JART COMMENT SUMMARY TABLE – Noise

Please accept the following as feedback from the Burlington Quarry Joint Agency Review Team (JART). Fully addressing each comment below will help expedite the potential for resolutions of the consolidated JART objections and individual agency objections. **Additional, new comments may be provided once a response has been prepared to the comments raised below and additional information provided.**

JART Comments (May 2021)	Reference	Source of Comment	Applicant Response (November 2021)	JART Response (May 2022)	Applicant Response (June 2022)
					Author: HGC Engineering Author: HGC Engineering	
						Report/Date: Noise Impact Assessment, April 2020 Report/Date: Acoustic Assessment Report – Halton Asphalt Supply, February 2020

Figure 5: Noise Barriers/Berms Near Site Entrance

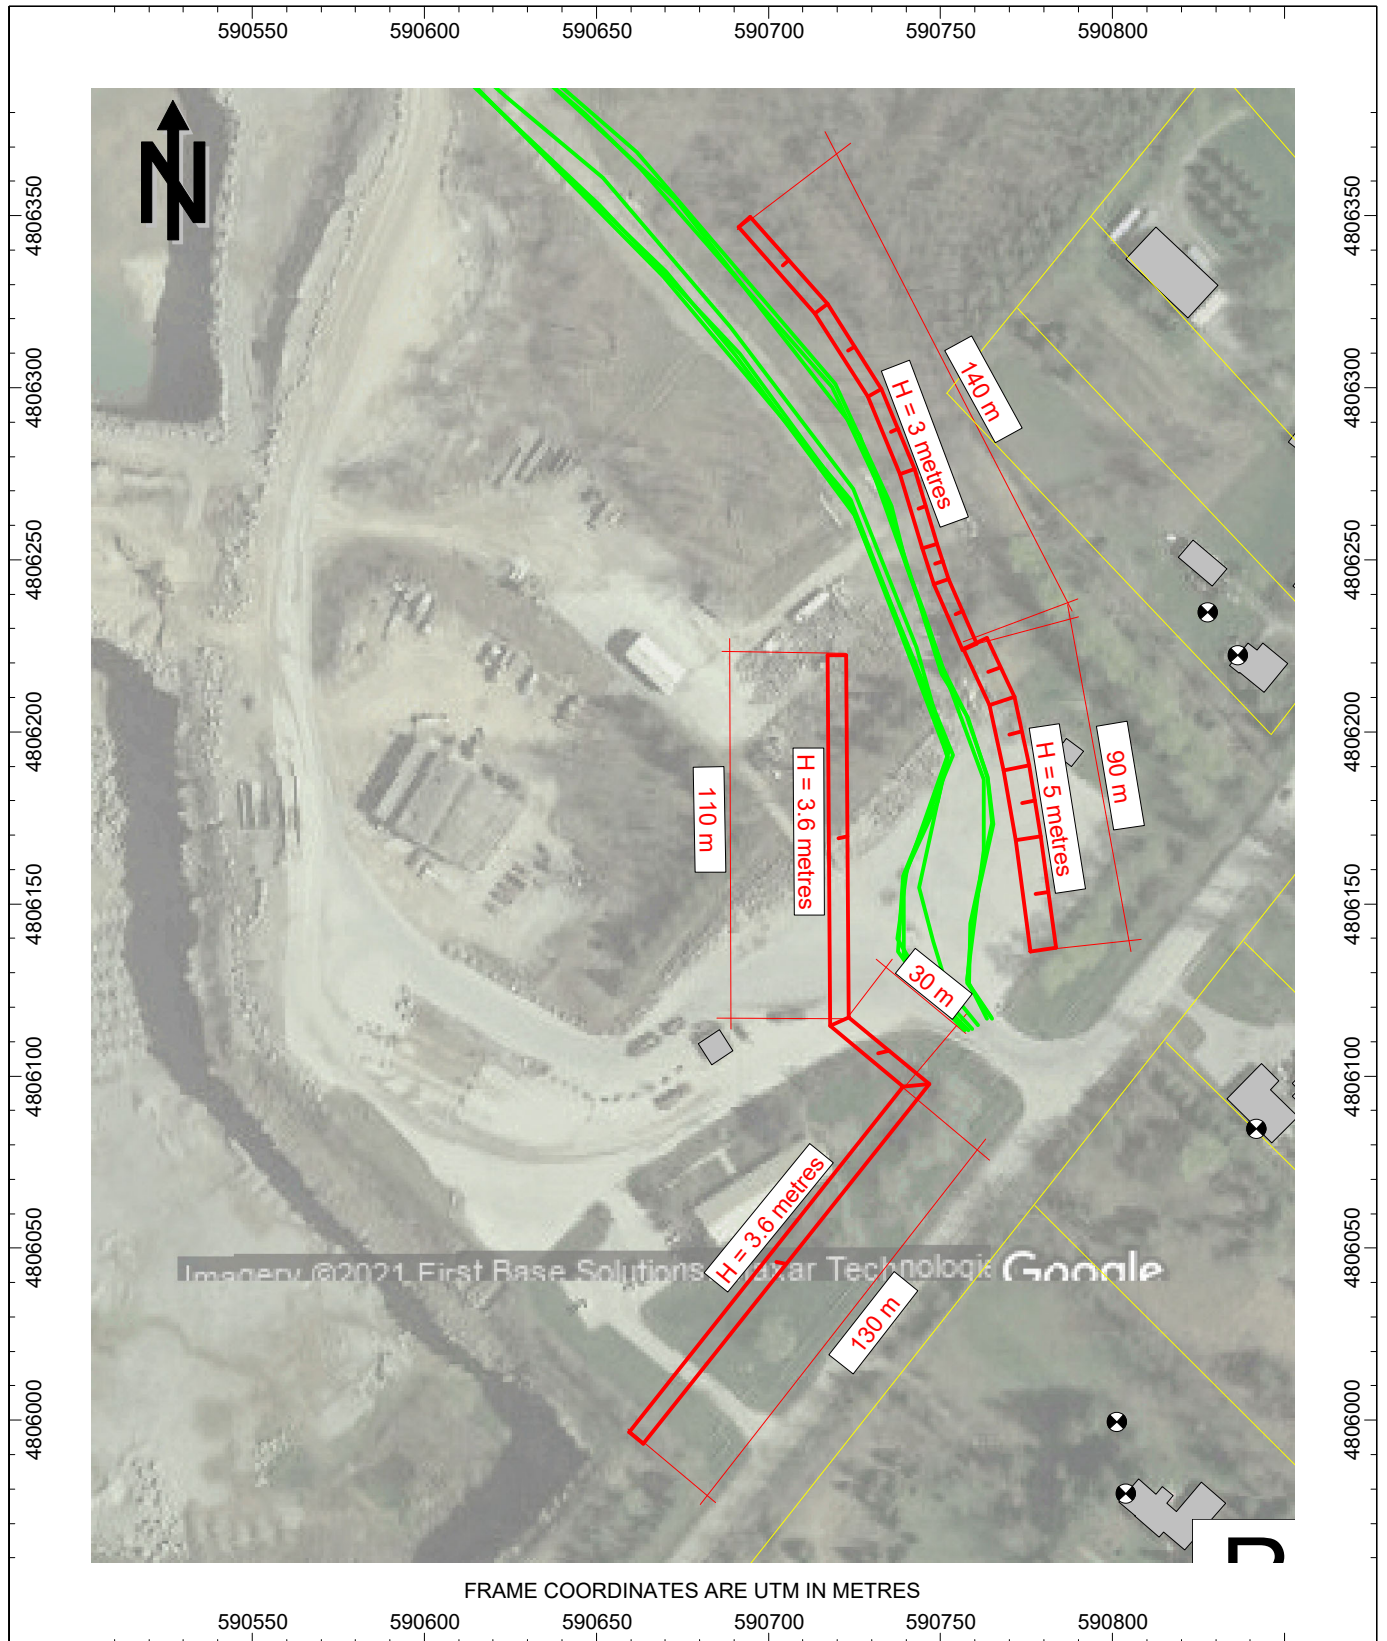
56.			City of Burlington		Is Figure 3a mislabeled as Figure 5? Noise Barriers/Berms Near Site Entrance	Yes, Figure 3a of the NIA is mislabeled as "Figure 5".

Figure 4a: Predicted Sound Level Contours at 1.5 m AG, Leq [dBA]
 Predictable Worst-Case Scenario During Extraction of South Extension - Phase 1
 Daytime Hours (7:00 - 19:00)

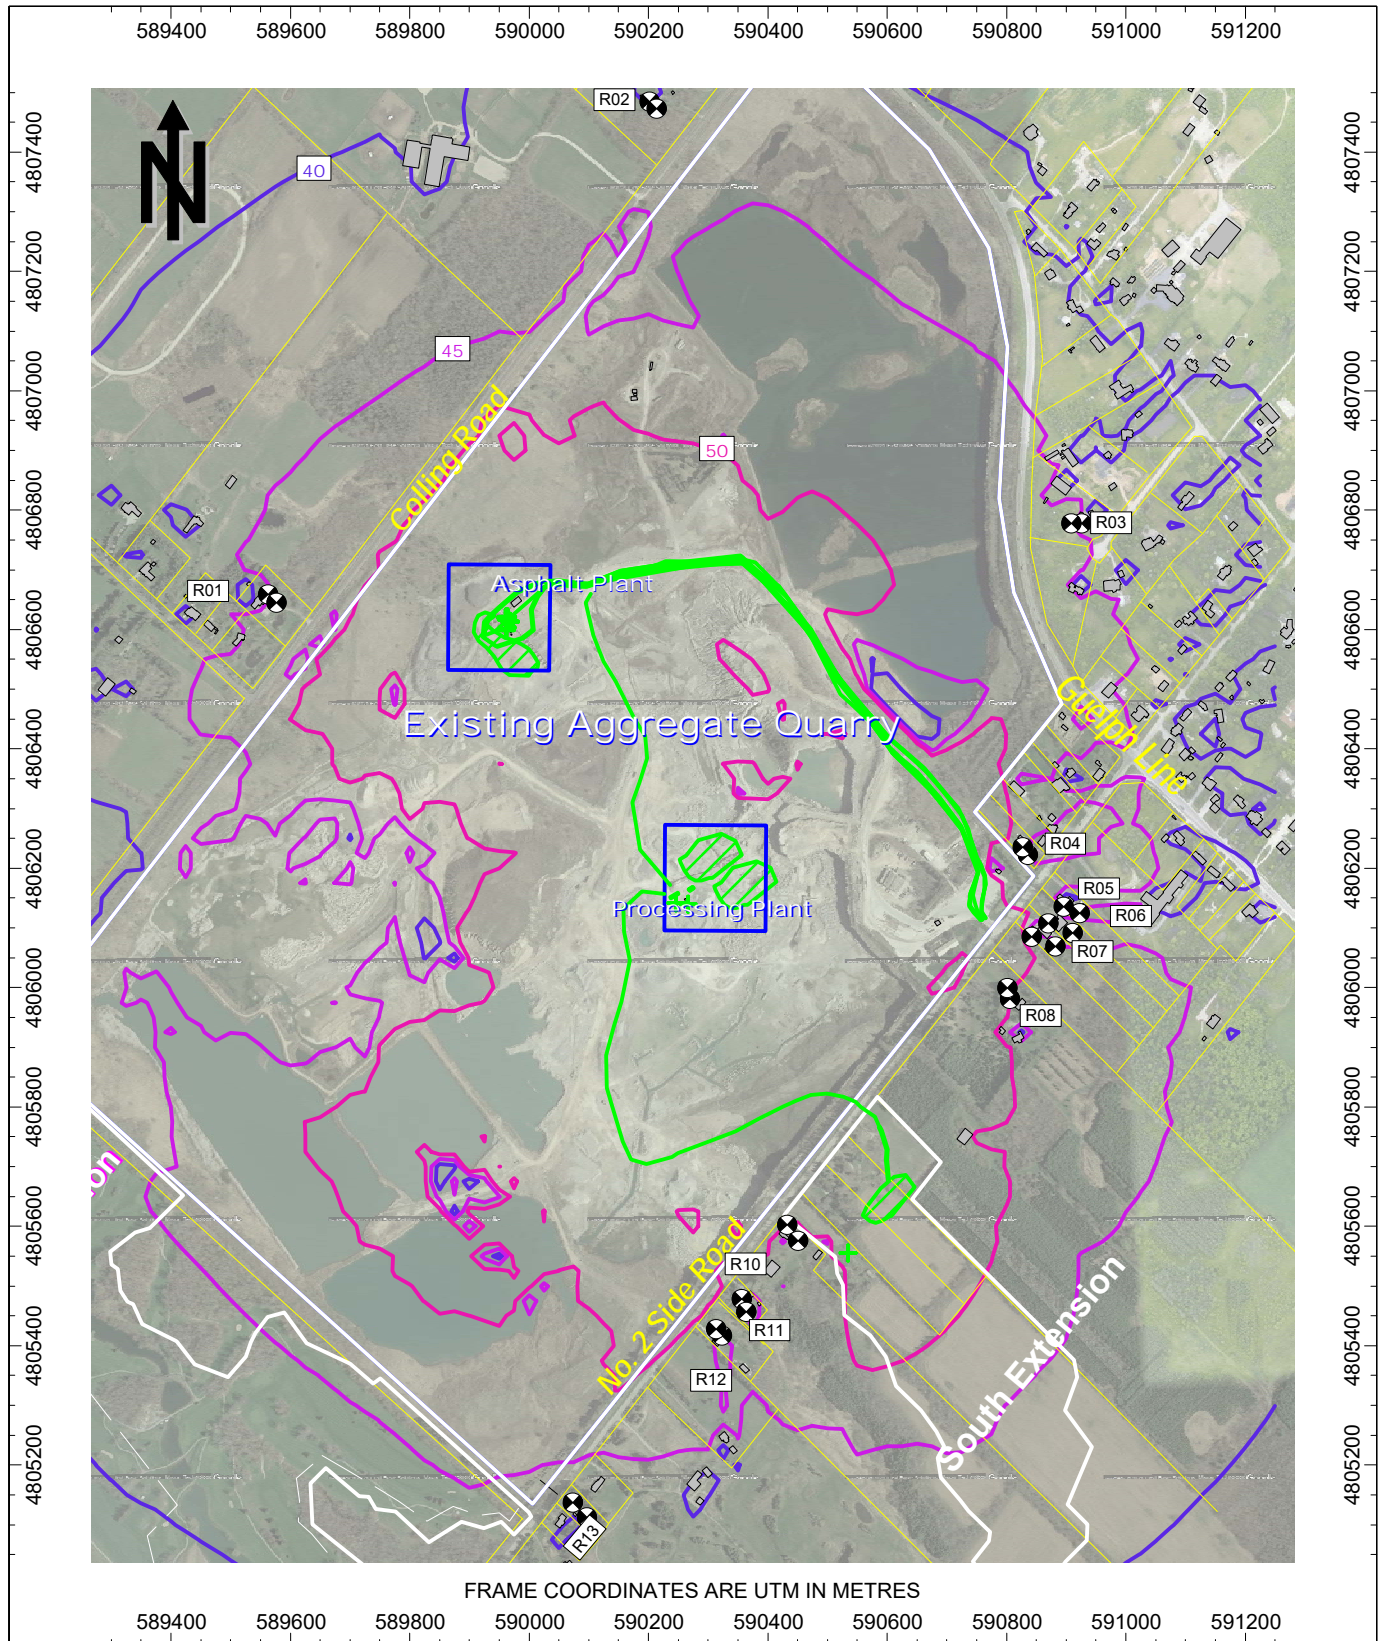
46.	Figure 4a identifies a 1.0-metre high barrier above the mixing tower. Please provide details, material, density, etc., will this need a building permit? Please reach out to the City's Building Department to confirm. Usually building permits are required for only permanent structures	General	City of	Based on results of the updated acoustic analysis, the noise barrier for the mixing tower is no longer required.	Addressed.	No further comment required.

Figure 4b: Predicted Sound Level Contours at 1.5 m AG, Leq [dBA]
 Predictable Worst-Case Scenario During Extraction of South Extension - Phase 1
 Night-time Hours (19:00 - 7:00)

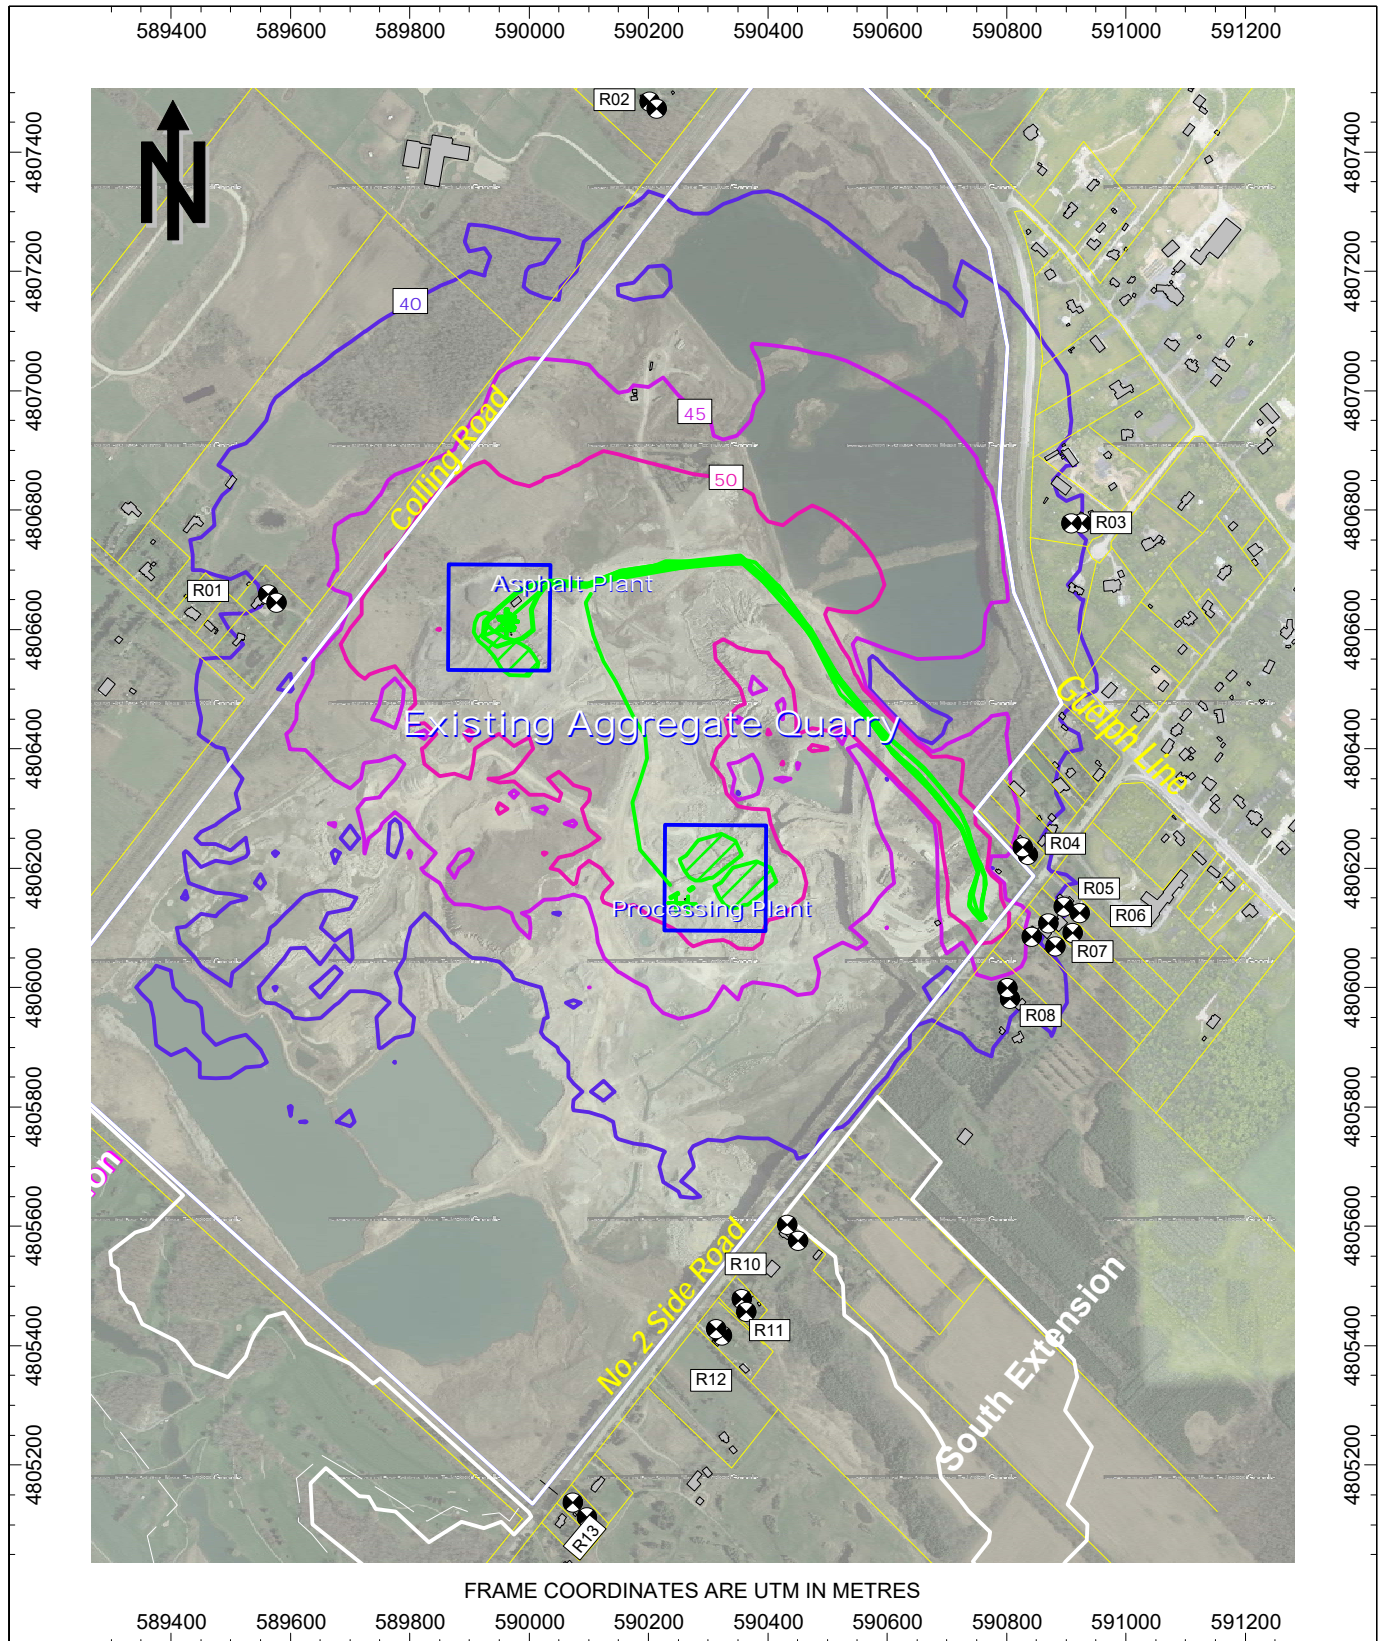
48.	Figure 4b identifies a 5.0-metre high barrier around the drill. Please provide details, material, density, etc., is it a portable barrier, will this need a building permit? Please reach out to the City's Building Department to confirm.	Section 2.2 (Page 4) Last Sentence	City of Burlington	The updated NIA and AAR no longer include a recommendation for a noise barrier at the hot-mix asphalt plant.	Please include in Appendix C of the NIA and on the Sound Power Level table on the Operations Plan and/or the ARA Site Plan, that the "quiet drill (110dBA)" is to be utilized on site.	Referring to this equipment as a "quiet drill" offers no technical specificity; only the maximum allowable sound power level of the equipment is of technical relevance and is referenced in both the NIA and on the ARA Site Plan.

Figure 2: Adjacent Properties and Assessment Locations

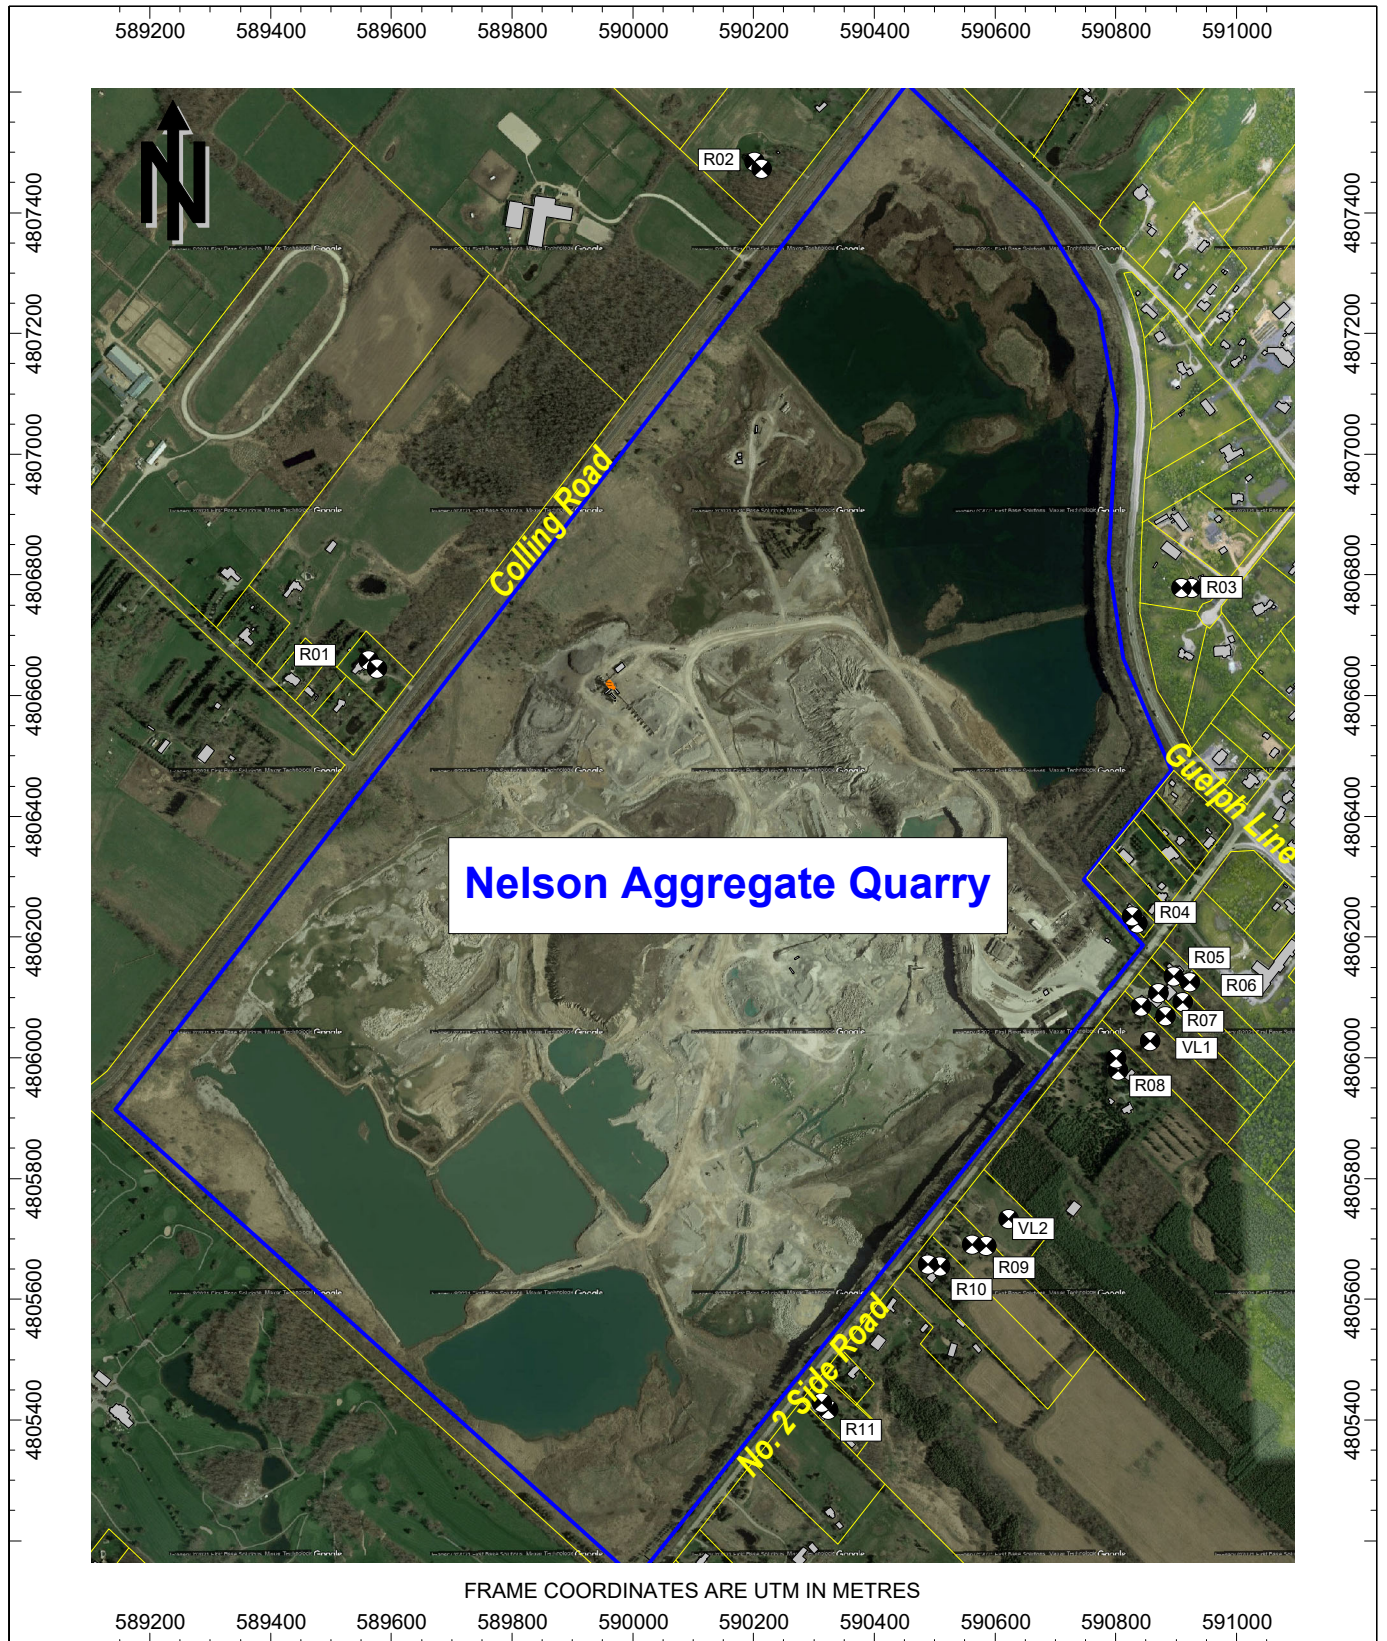
43.	There was a calculation summary provided for R01, R02, R03, R04, R05, R06, R07, R08, R09, R10, R11, VL1, and VL2. Figure 2 provides general locations of receptors but the report does not clearly identify the municipal addresses of the receptors. Would ask that the municipal addresses of the receptors be provided in a separate table (or on Table 2 & 3) so that they can be clearly identified by the general public, as all reports submitted in support of the OPA are public information and available for view on the City's website.	General	City of Burlington	An updated AAR (included as Appendix F to the updated NIA) has been submitted to the MECP in support of an application to amend the ECA for the onsite hot-mix asphalt plant. As noted in the response to Comment 2, the MECP Senior Noise Engineer has completed their review of the AAR. Therefore, the AAR cannot be further updated. Nevertheless, the updated NIA includes the municipal address of each point of reception in Tables 2 and 3 of Section 7 and Appendix D.	Addressed.	No further comment required.
